# Site Accessibility Evaluation

## Walker Park

6078 Otter Creek Rd SE  
Lone Tree, IA 52755

ADA Only

### Finding: 2

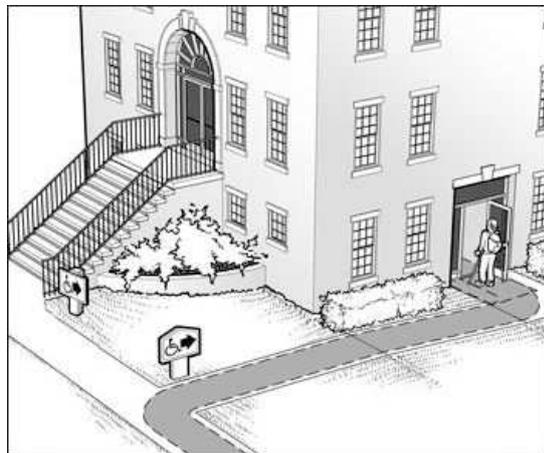
The building entrance is not located on an accessible route.

grass to cabin

Create AR with crushed and compacted stone or similar outdoor material from parking or sidewalk to building entrance

## Finding: 3

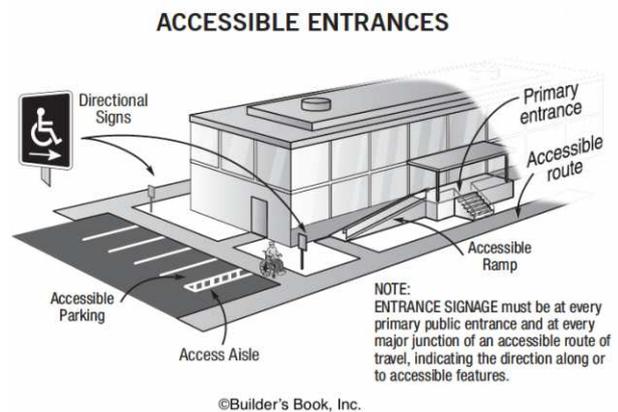
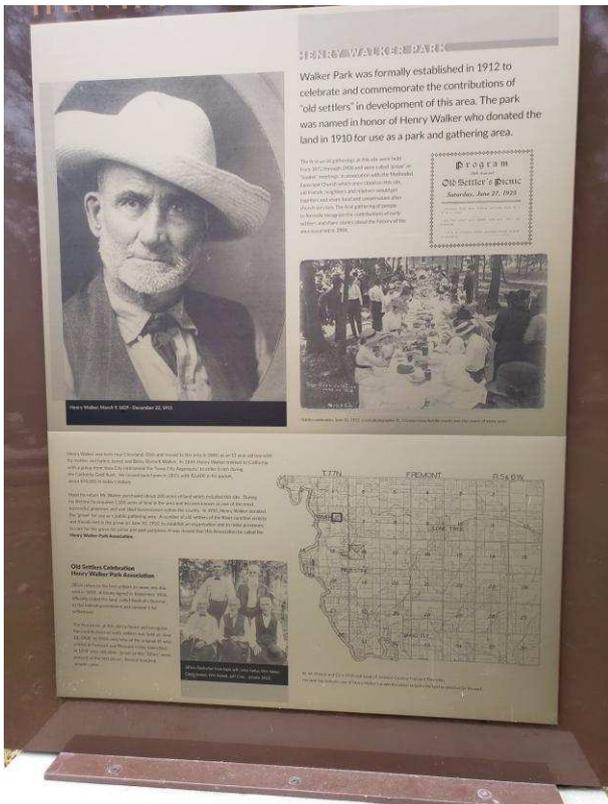
There is no accessible route to the park sign.

park sign- lacks AR,  
grass, text small in  
some spots

Create an accessible route with crushed stone or other outdoor material from parking to the sign and consider replacing with one having larger font

## Finding: 5

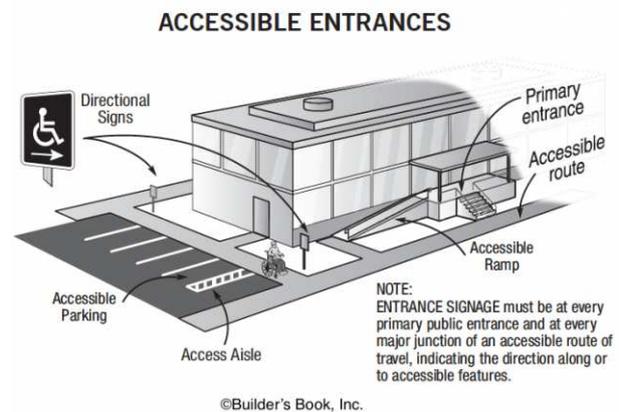
There is no accessible route to the memorial building

no route to memorial building, unable to access interior, change in level at door

Create an accessible route with crushed stone or other outdoor material from parking or walkway to memorial building

### Finding: 8

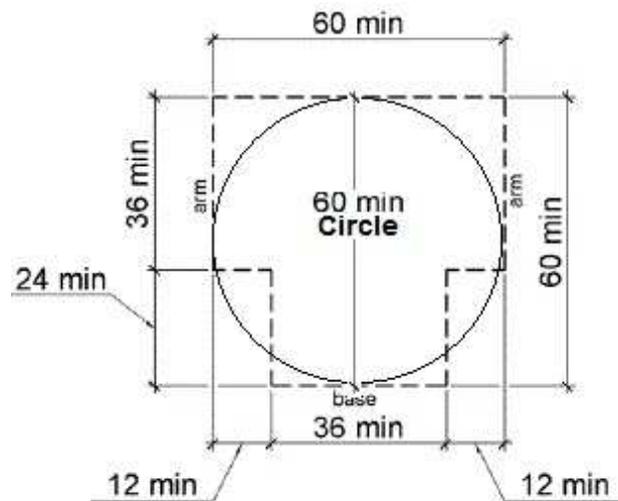
There is insufficient turning space within this room or space.

lacks turning space  
due to table  
configuration

Relocate obstacles to create turning space in shelter

### Finding: 9

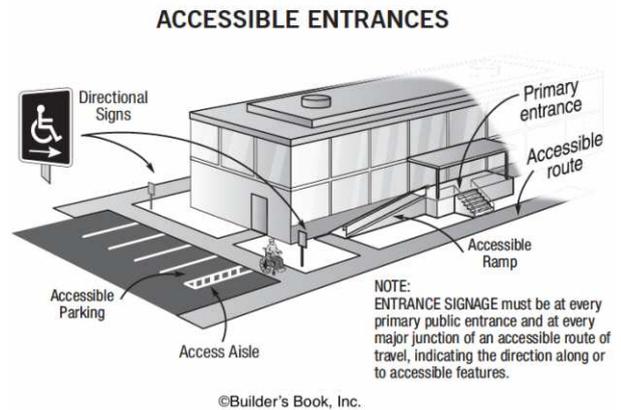
There is no accessible route to the grill..

lacks AR at grill

Create an accessible route with crushed stone or other outdoor material from parking to grill

### Finding: 11

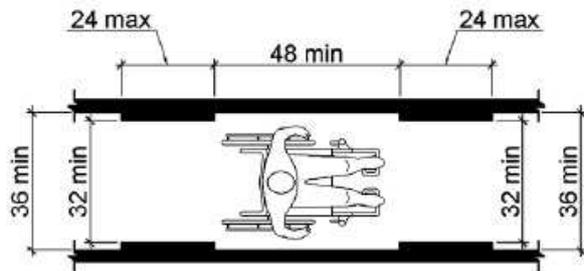
The route of travel at this location does not provide a minimum width of 36 inches.

interior full of storage

Widen AR to compliant 36" clear width by removing or relocating storage

### Finding: 12

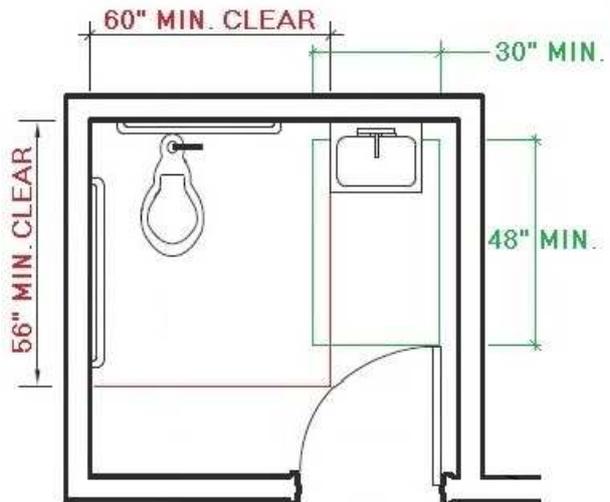
The restroom is not nearly compliant.

The restroom does not have the required minimum clear floor space or maneuvering clearances for the toilet, The restroom does not have the required minimum clear floor space or maneuvering clearances for the lavatory, The entry door does not contain the required minimum maneuvering spaces on the pull/push sides, The entry door encroach into the required clear floor space for fixtures, Grab bars are missing and/or incorrectly installed, Accessories, such as toilet seat covers, paper towel holders, garbage cans, hand dryers, and mirrors are either too high or without clear floor space or both, The restroom contain floor level changes greater than a 1/2 inch of the floor drains and is slope (XX) - (XX), the shower is too small and missing numerous accessible elements.

lacks accessible  
restrooms, 1 men and  
2 women

Create a compliant wheelchair accessible restroom and correct all features to be accessible
